FOI reference: 24-144

From: [Henriquez, Jose](#)
To: [GarciaBermudez, Diana](#); [TCCS_DC DevelopmentCoordination](#)
Subject: FW: Blocks 25 & 26, Section 43, 100 & 102 Macarthur Place, O'Connor ACT - Proposed Development Waste and Streetlight query TTW_239126:
Date: Wednesday, 20 December 2023 8:23:59 AM
Attachments: [twemailsignature.jpg_5698af16-5816-4e5c-8dfa-c2371491fc7b.png](#)
[C02 Concept Plans - Ground Floor.pdf](#)

Proposed Multi-Unit Housing
 Blocks 25 & 26, Section 43, 100 & 102 Macarthur Place O'CONNOR ACT

Concept Plans: Ground Floor
 Scale: As Shown @ A3

Image 1

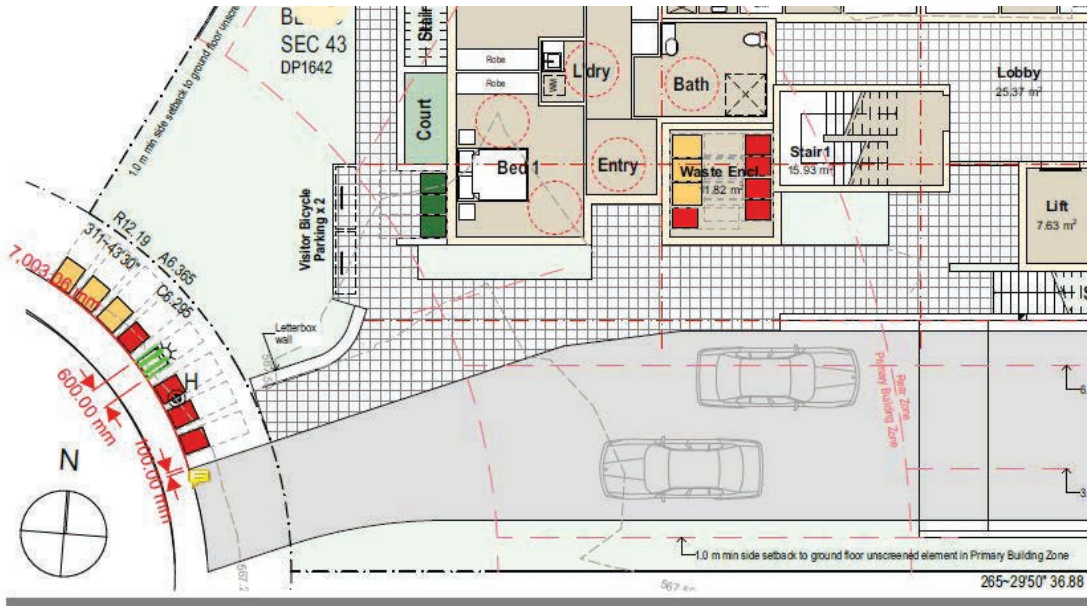
As discussed with ACT No Waste, the waste and recycling calculation were not worked out (as shown in Image 1 below) according to the Waste Code requirement as 5 x 240L waste and 6 x 360L recycling bins are required. Even if one could delete one waste bin, they would still not fit on the kerb. Onsite collection through a reversing side-lift truck is not permitted.

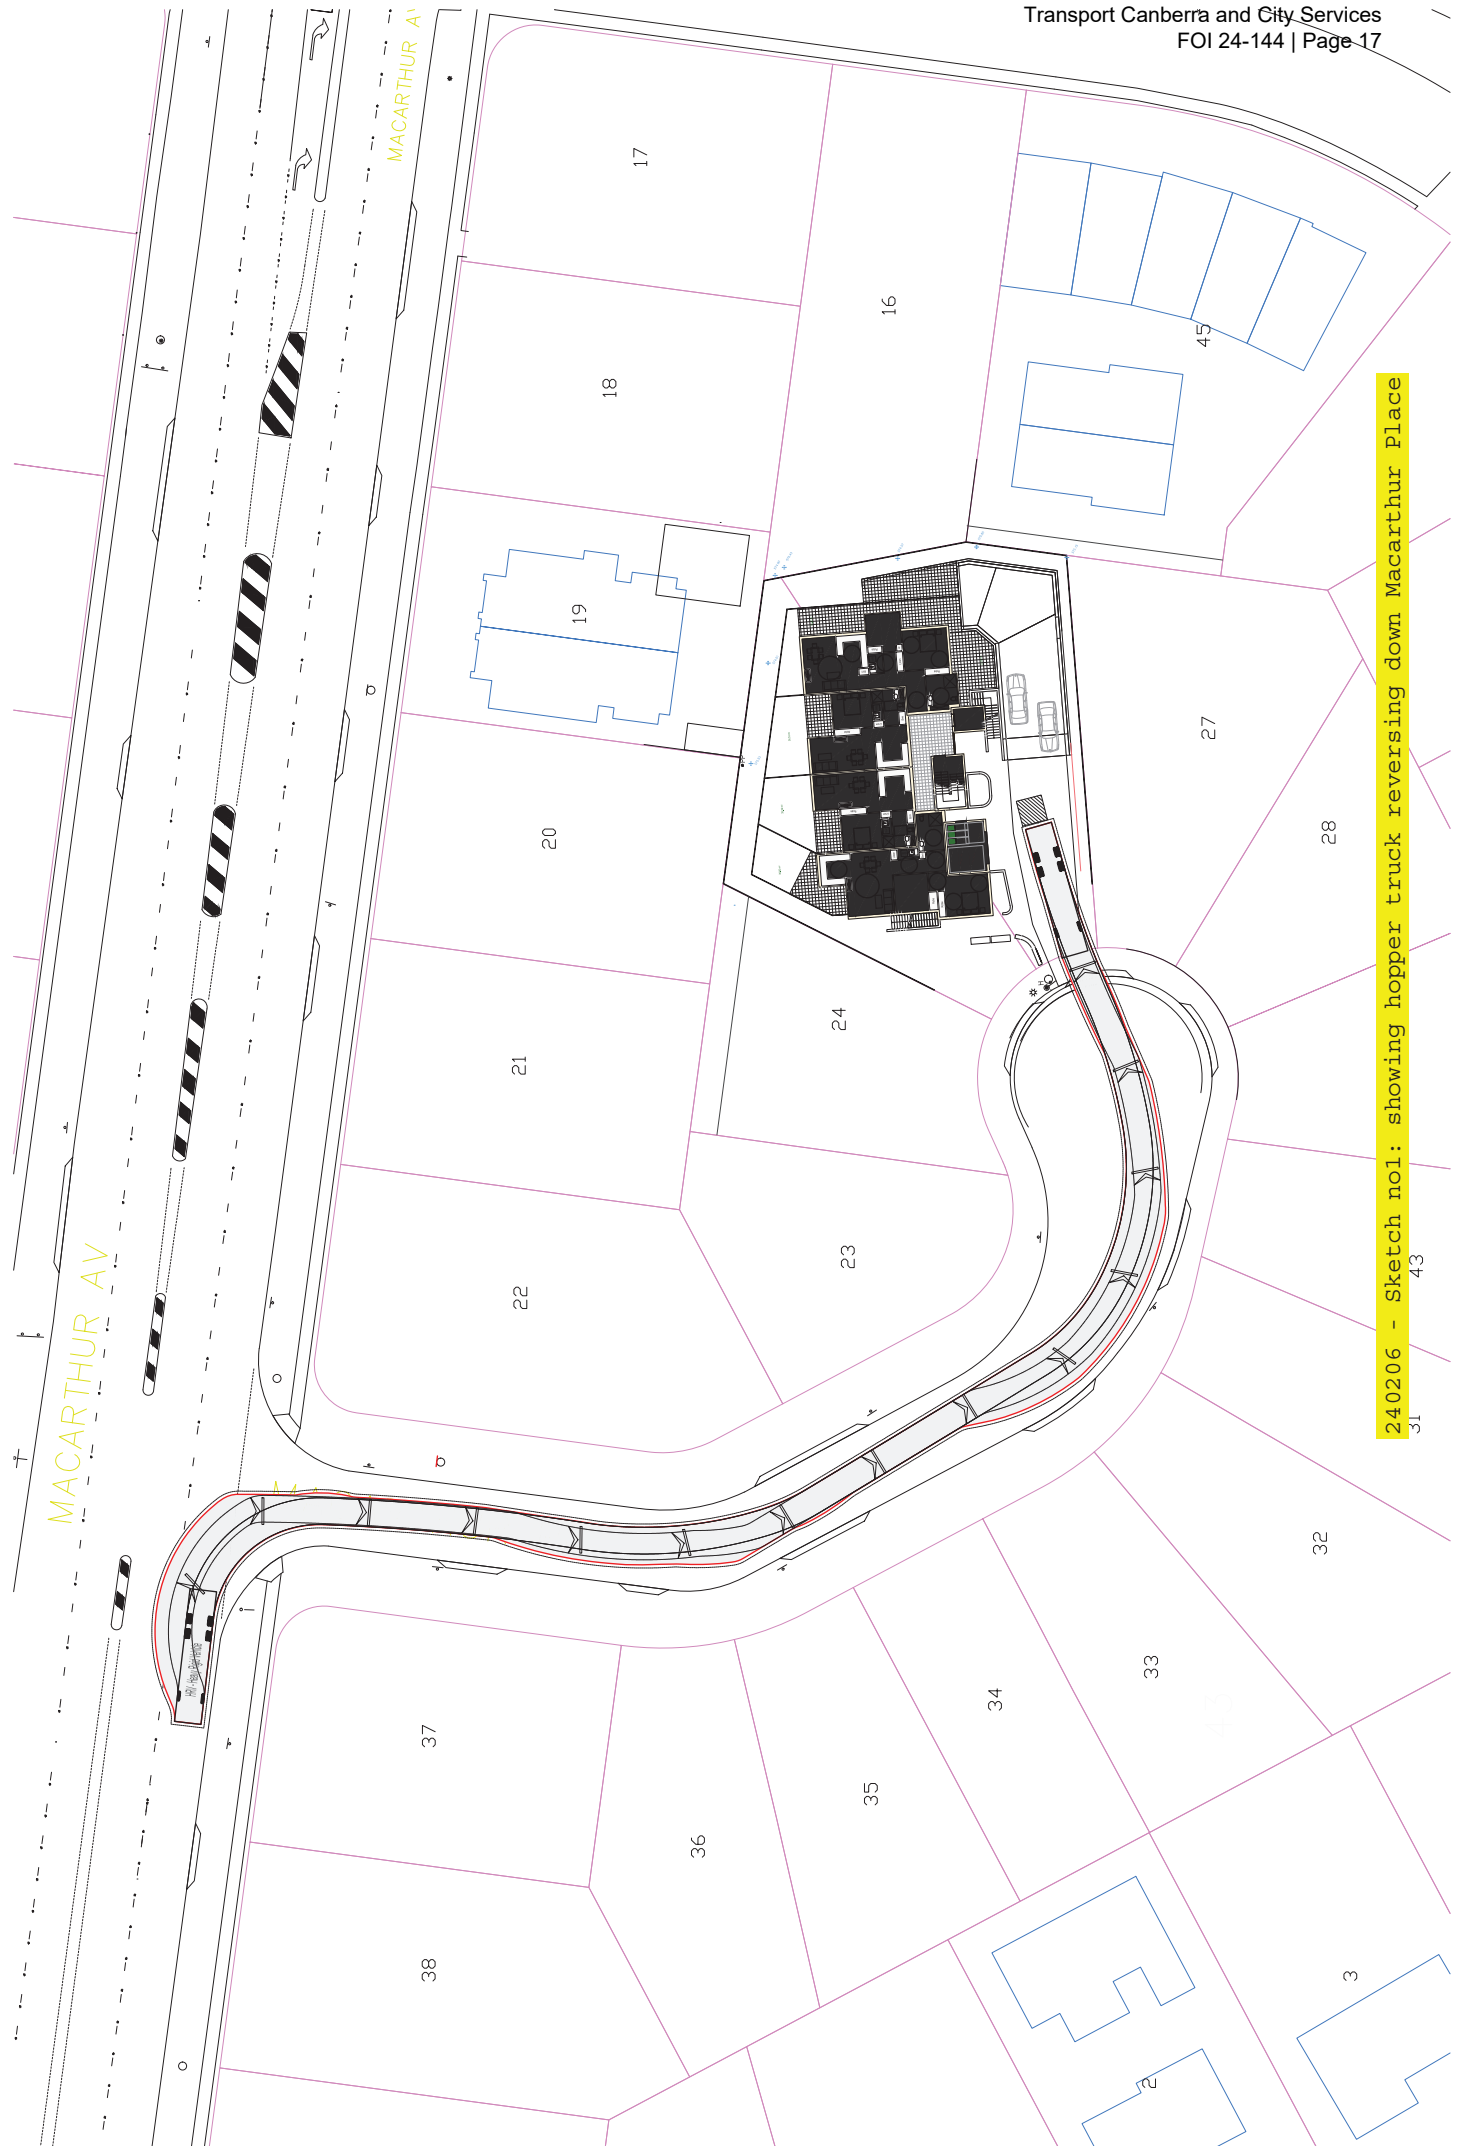
There is insufficient space on kerb as there is only 6.9m free space, with 100mm clearance to an already reduced 3m wide driveway (Clearance from DCCfWM-2019 Figure 3.2). This 6.9m also includes a streetlight obstruction. It is preferable the streetlight not be relocated, which would reduce free kerbspace by a further ~600mm

Reducing bins required to nominally 4x waste, and 4x recycling, would take up 6.6m of kerbspace, which will fit if the lightpost is removed, or relocated further back into verge outside of clashing with bin collection, or relocated to a neighbours verge.

If an additional bin was removed, then the lightpost could remain.

Can you please advise on possibility of relocating lightpost.

A pre-application meeting must be held to discuss how you propose to mitigate the risks of a Heavy Rigid Vehicle (HRV) reversing into the driveway. Also, you need to demonstrate that your documentation complies with Table 3.8 of the Waste Code, which should show the number of hoppers required, their location, and how traffic will be managed onsite.

240206 - Sketch no1: showing hopper truck reversing down Macarthur Place
31 43

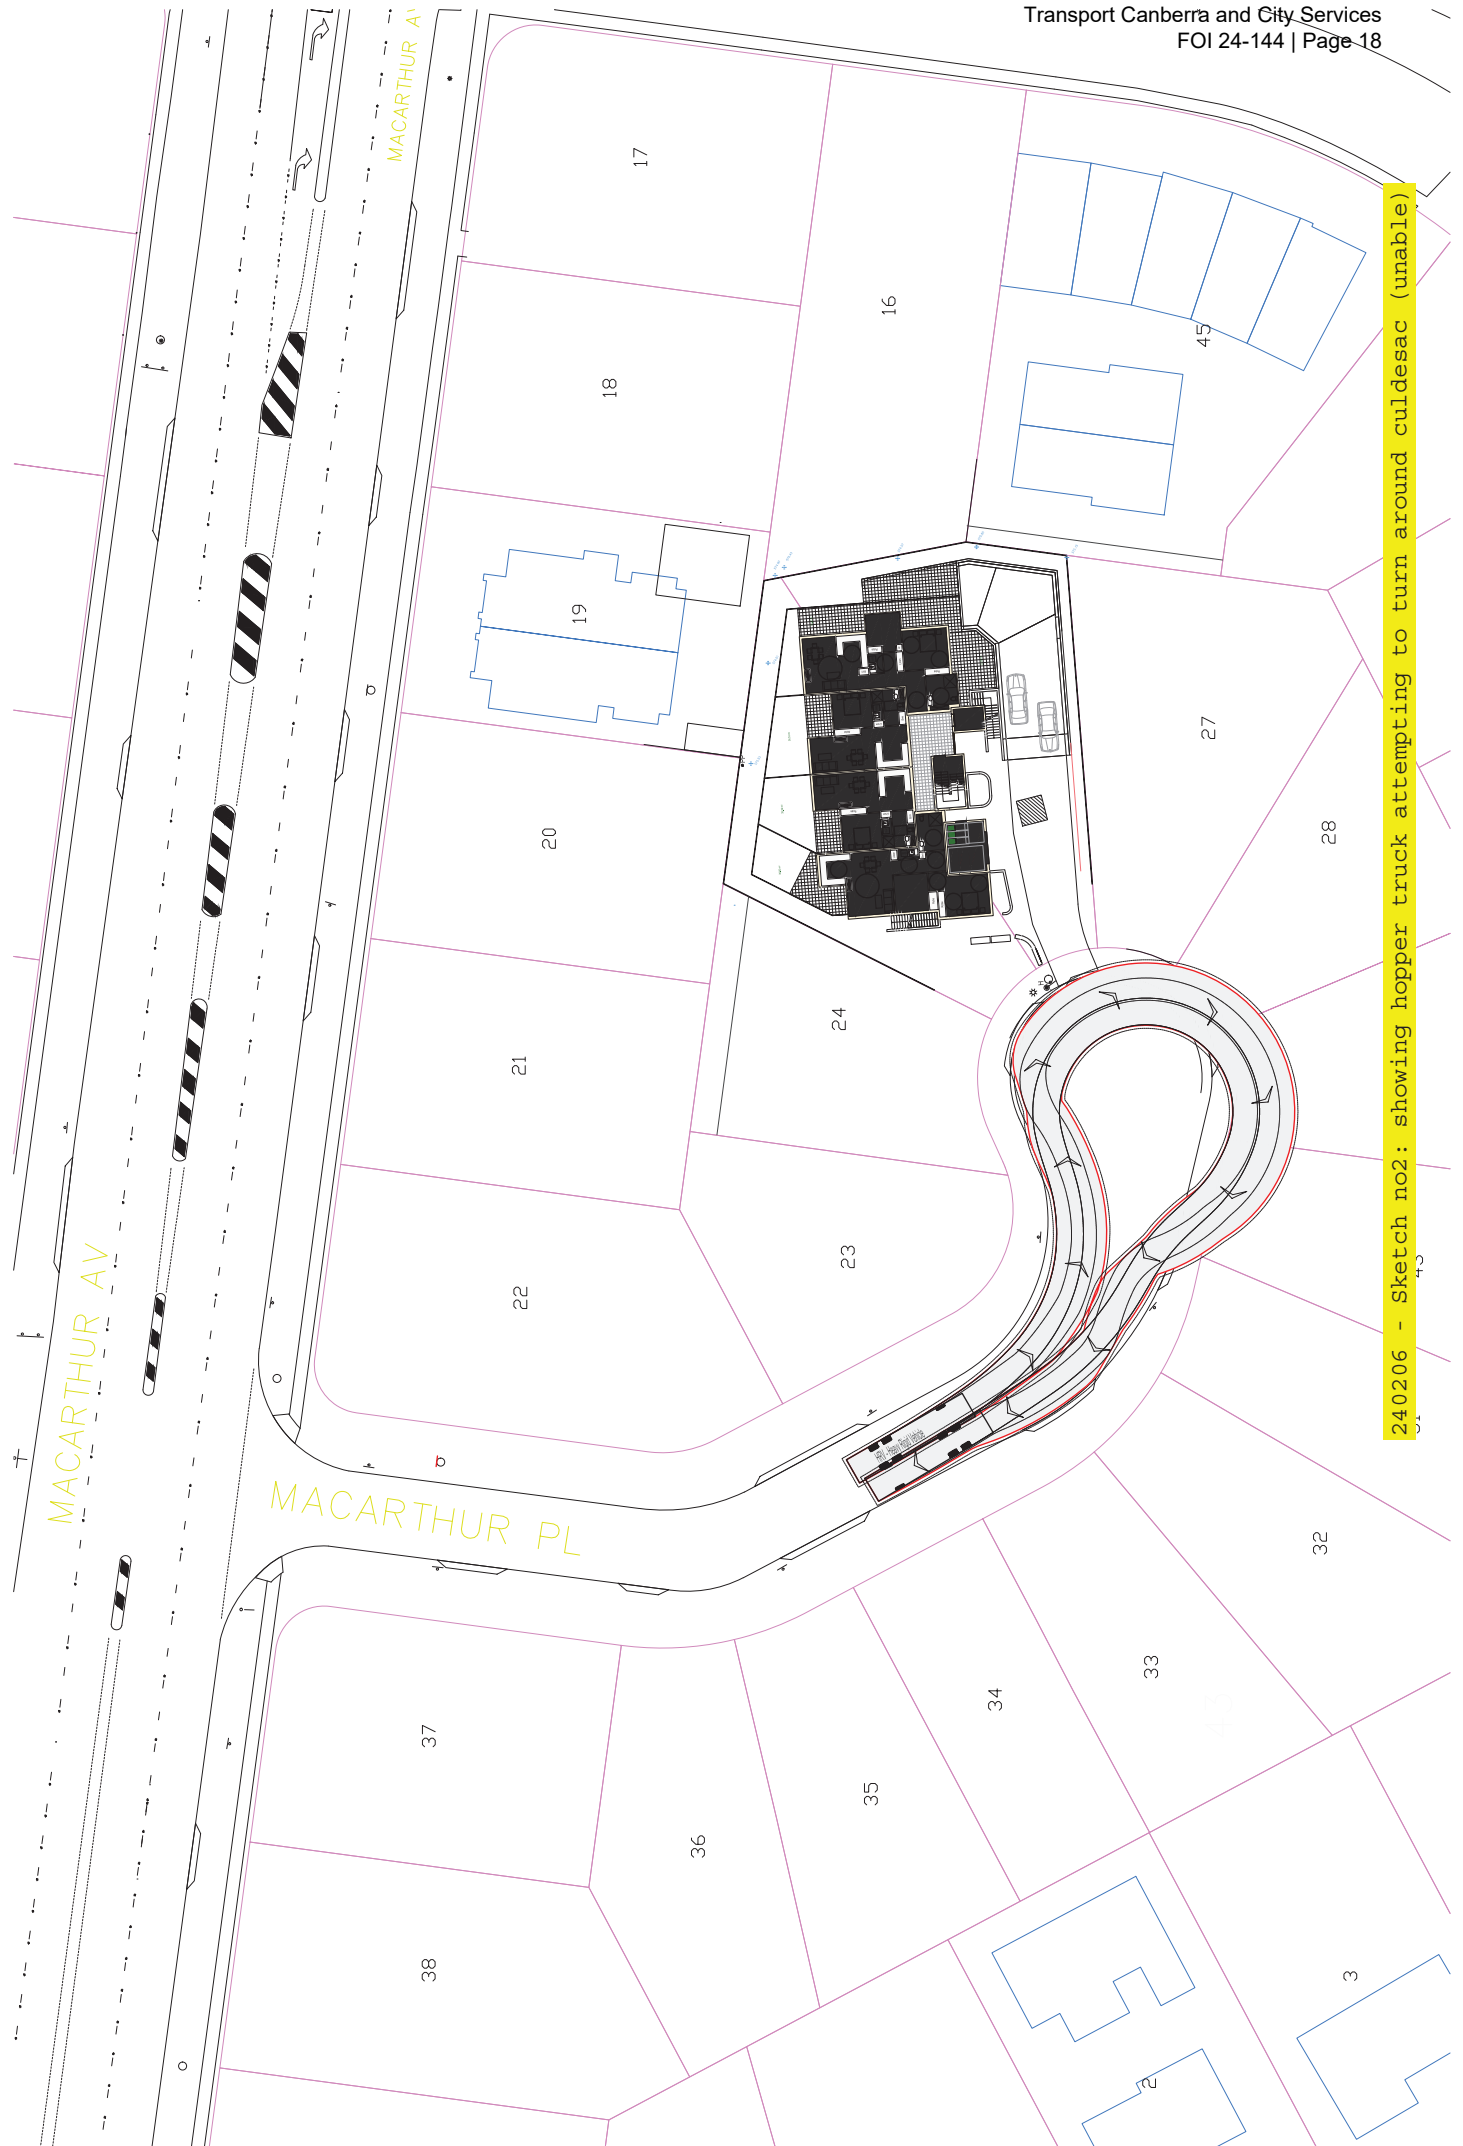
Attached is updated plans showing performance-solution of reverse in access to site and onsite hopper collection.

240206 - Sketch no2: showing hopper truck attempting to turn around culdesac (unable)

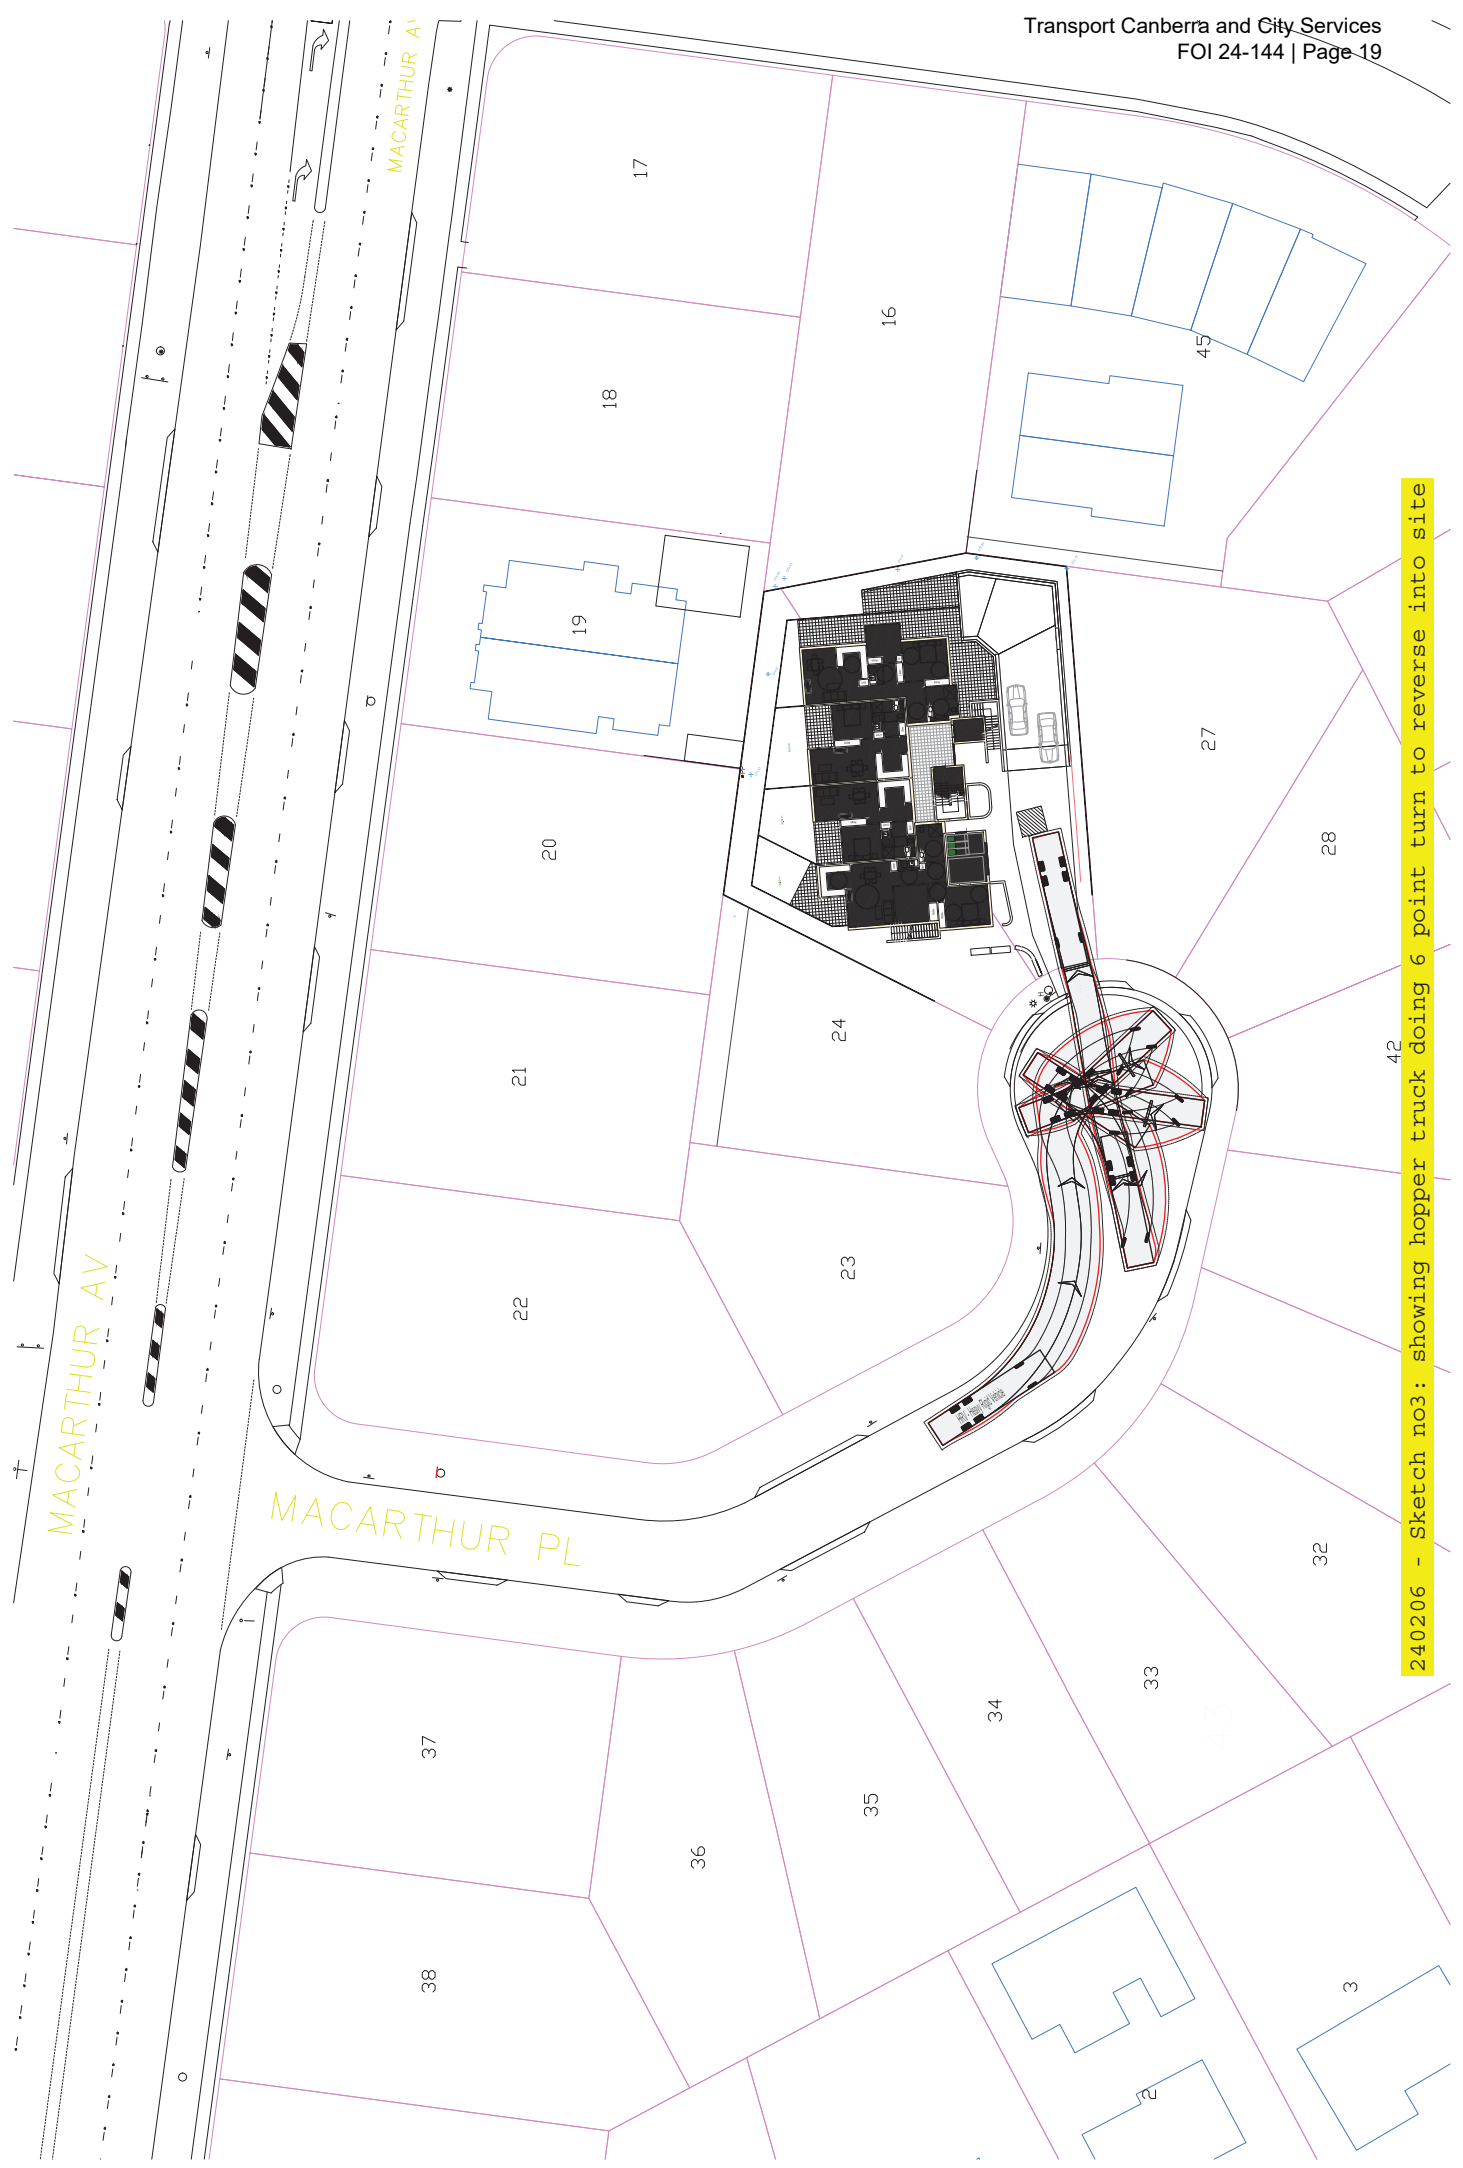
240206 - Sketch no3: showing hopper truck doing 6 point turn to reverse into site

Image 1

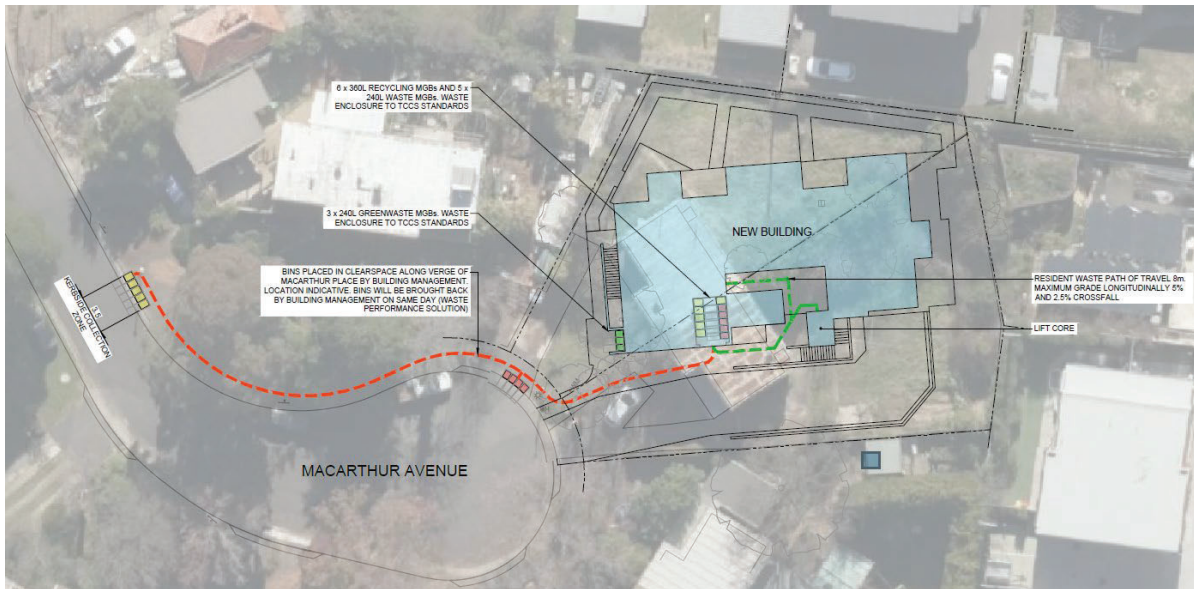
As discussed at the meeting, you need to provide all the information about the MGB's to be carted, including the following:

- Carting distances as the furthest an MGBs can be carted is 75m from the waste enclosure to the furthest MGB. Please provide updated plan showing the distances.
- You need to identify the best spot to present the MGBs and investigate what properties also present their MGBs there as not to overcrowd the kerb with MGBs.
- Therefore, you need to provide property details (addresses) so that we might inform the owners [REDACTED] that MGBs from another property will be presented in front of their property as shown in Image 1 below.
- As mentioned, Building Management will cart the bins, however, please provide the information of which mechanism will be used.
